**ADDENDUM NO. 5
IRONDALE PUBLIC LIBRARY**

CITY OF IRONDALE

THIS ADDENDUM FORMS A PART OF THE CONTRACT DOCUMENTS. THE FOLLOWING CONDITIONS TAKE PRECEDENCE OVER ANY CONFLICTING CONDITIONS IN THE DRAWINGS AND SPECIFICATIONS. THE DRAWINGS AND SPECIFICATIONS ARE HEREBY AMENDED IN THE FOLLOWING PARTICULARS.

SHEET NUMBER
C4.01

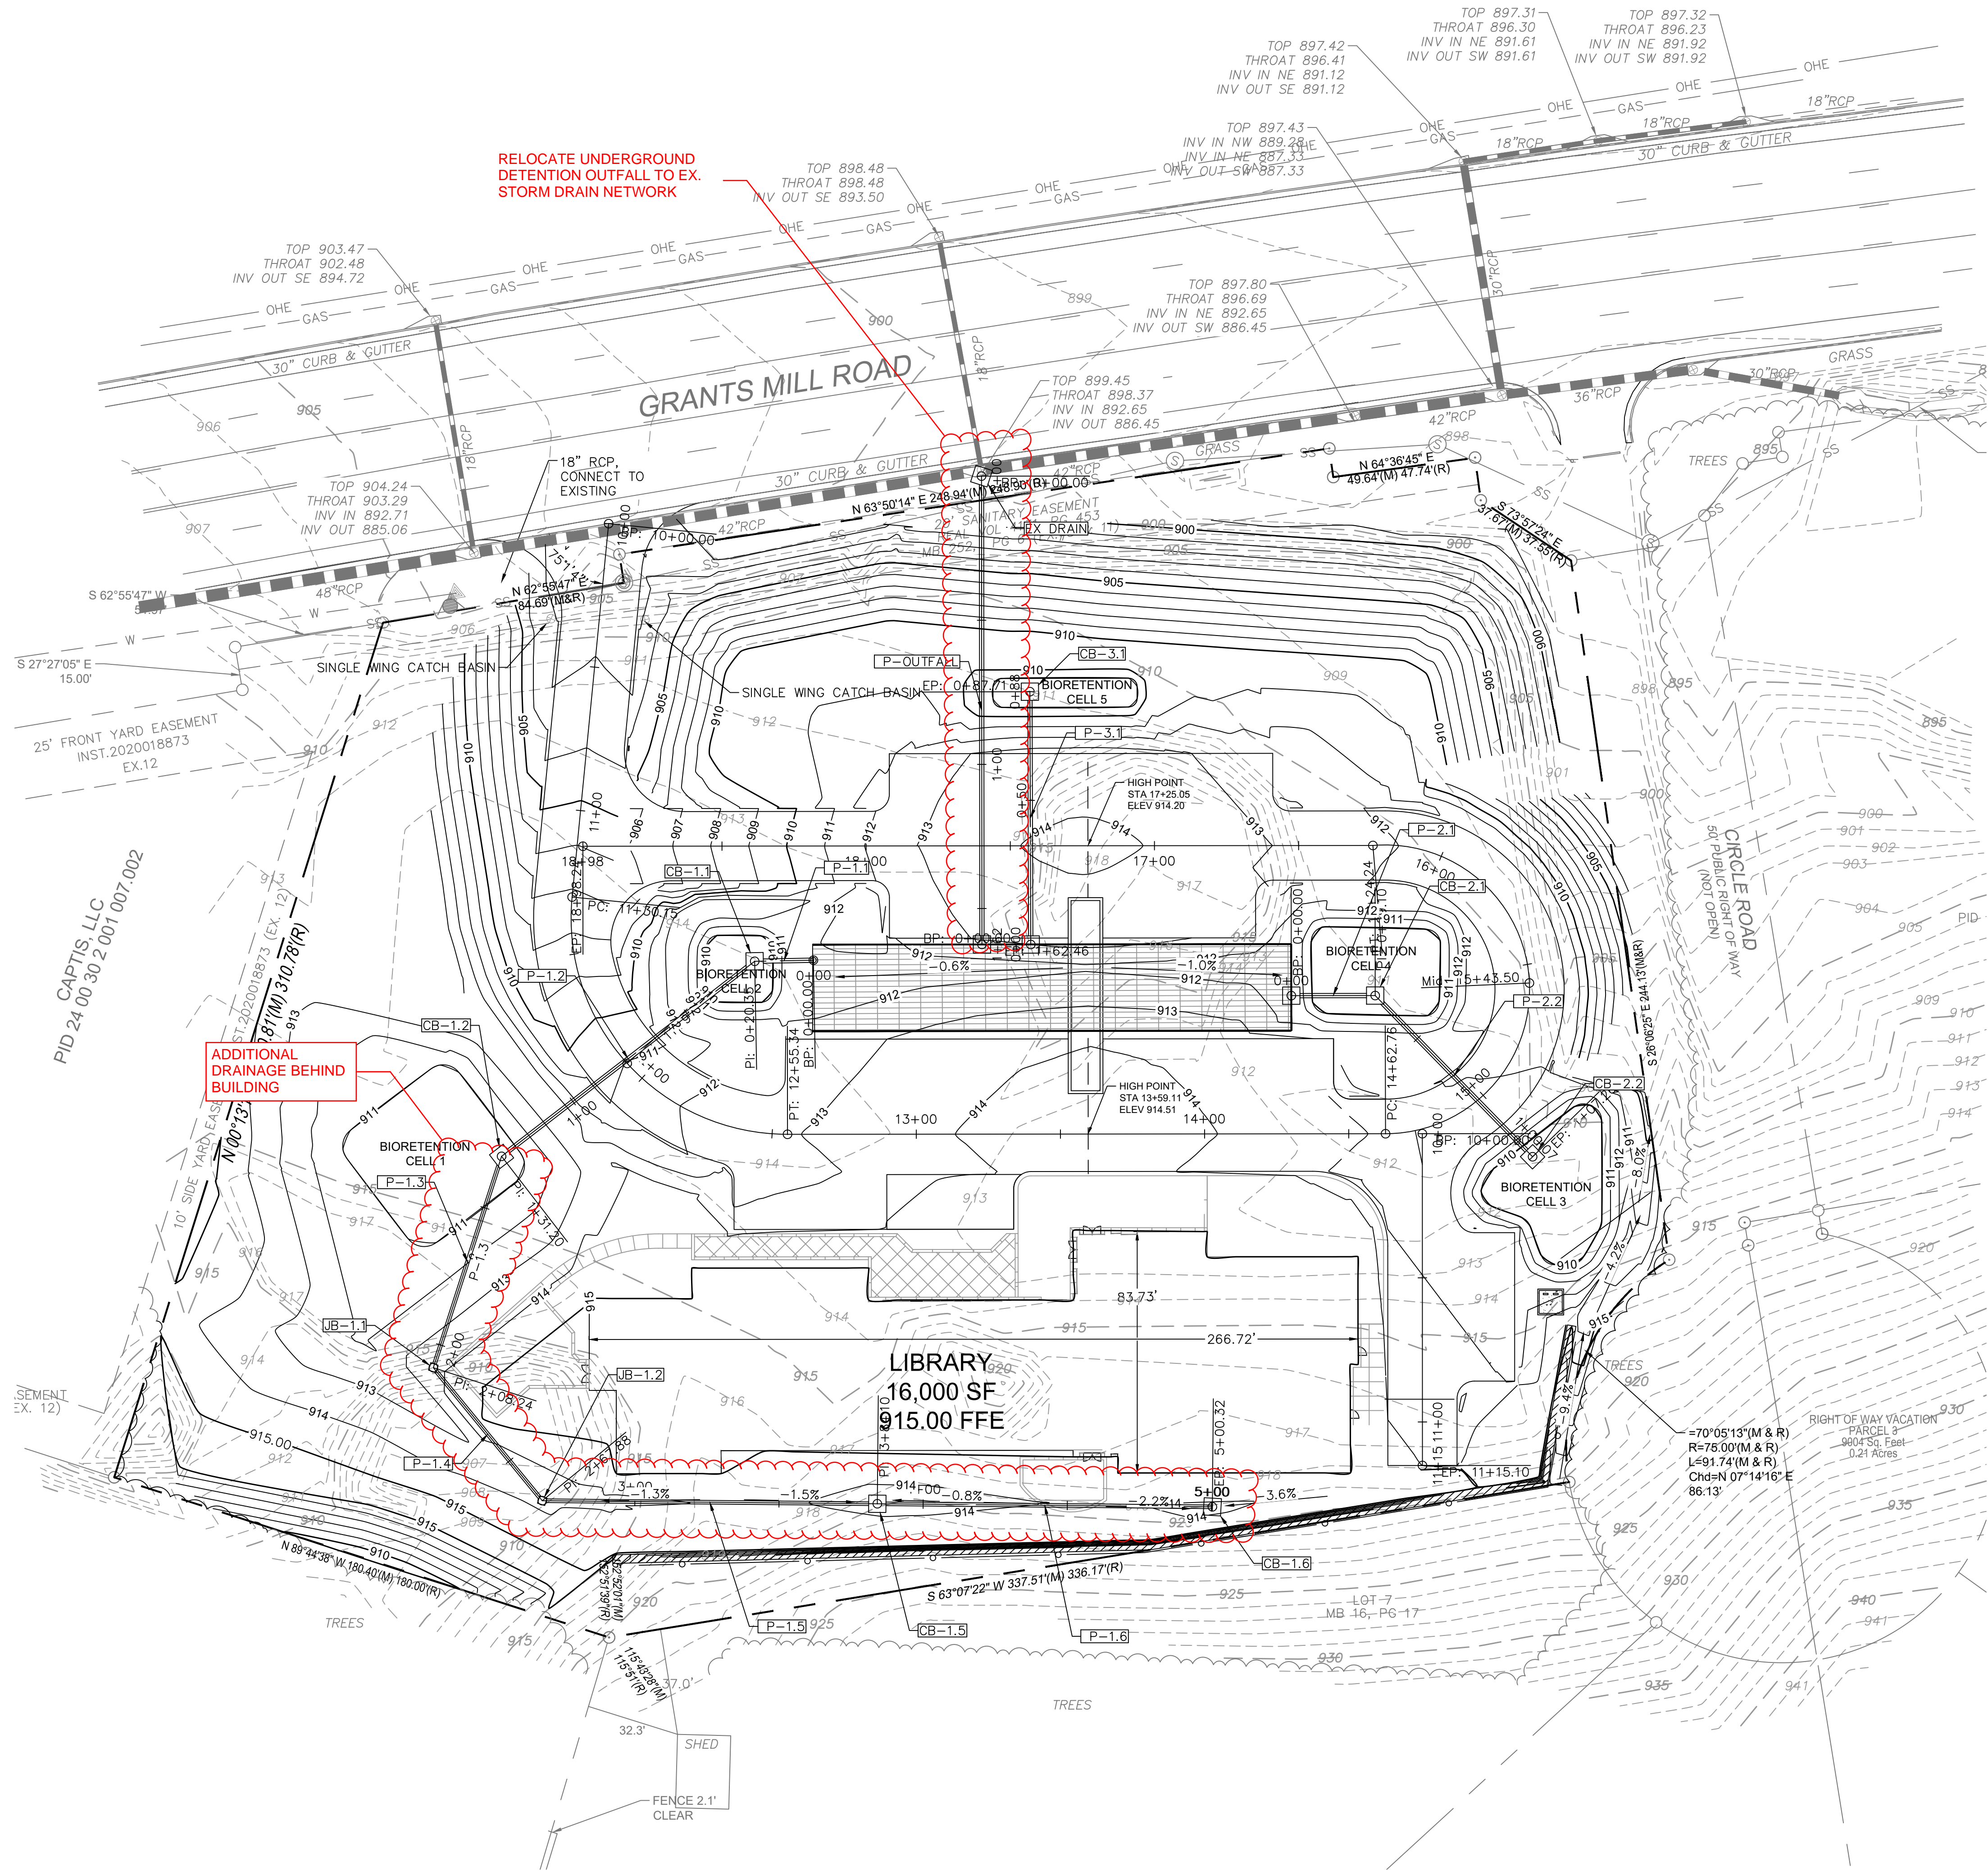
11. Neither the civil grading plan, sheet C4.01, nor the hardscape plans, sheets L1.01 and L1.02, show any grades for the dry creek beds. Sheet L1.01 and L1.02 reference detail 7/L1.03 for the dry creek bed which shows a cross section of a swale which is not depicted in the grading of the site. Please provide grades and details of where and how this dry creek swale are intended to be built and drain to.

12. General note 10 on sheet L2.04 calls for 6" of topsoil in shrub beds and all areas to be seeded. Will the existing onsite topsoil stripped during the grading operations be acceptable for re-use in these areas? Grading note 10 on sheet C4.01 calls for 4" of topsoil for areas not covered with pavement or building. Are we to provide 4" of topsoil or 6" of topsoil in seeded and landscape areas?

Response: See civil for elevations. See landscape detail 9/L2.04 for bio-swale detail and detail 7/L1.03 for swale when not called out as bio-swale

Response: 6" of topsoil. See specifications for soil amendments if needed based off soils report/testing to be provided by GC. Sheet C4.01 will be revised in coordination with Landscape plans to show grades at dry creek locations behind building and at SE corner of site. Grades also to be shown at island between parking aisles, to drain toward bioretention cells.
